SERVICE BULLETIN

M-868

ENGINE VEHICLE IDENTIFICATION NUMBER LOCATION CHANGE

Figure 1. Old Location of VIN

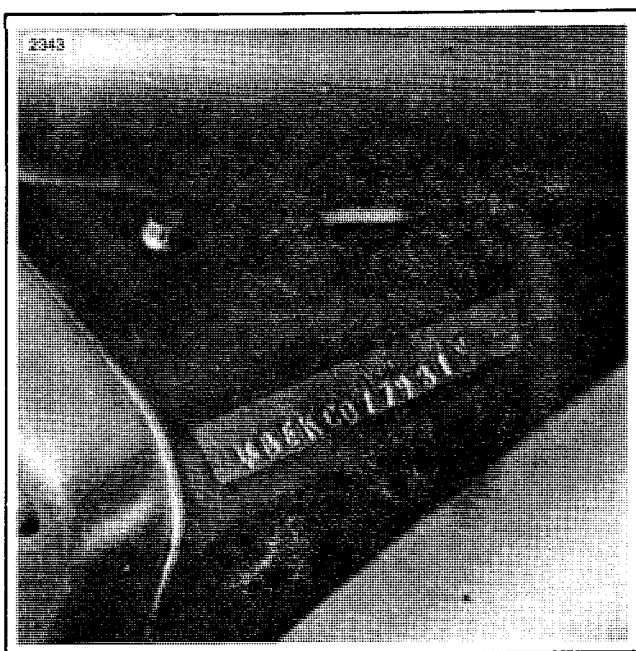
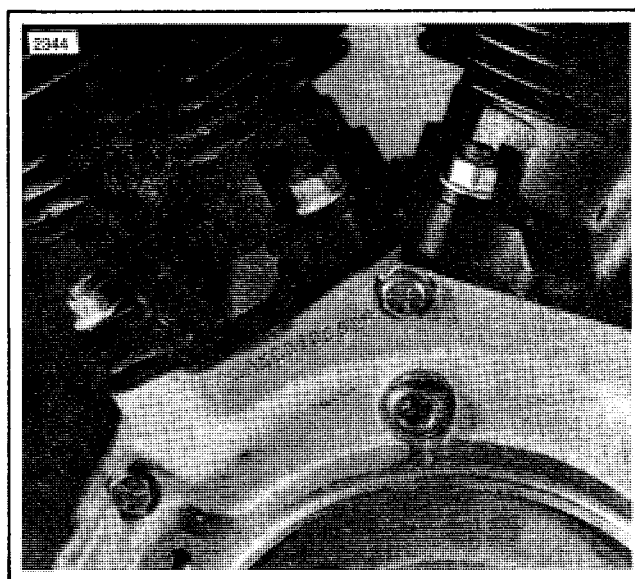
The location of the abbreviated vehicle identification number (VIN) on the 1340cc engines has been changed. The location of the VIN on the frame has not been changed.

See Figure 1. Prior to this change, the VIN was stamped into the upper front surface of the right crankcase.

Beginning with the crankcase numbers listed below, four stars have been stamped into the right crankcase half at the old VIN location.

See Figure 2. The VIN has been relocated to the left crankcase below the front cylinder.

Figure 2. New Location of VIN
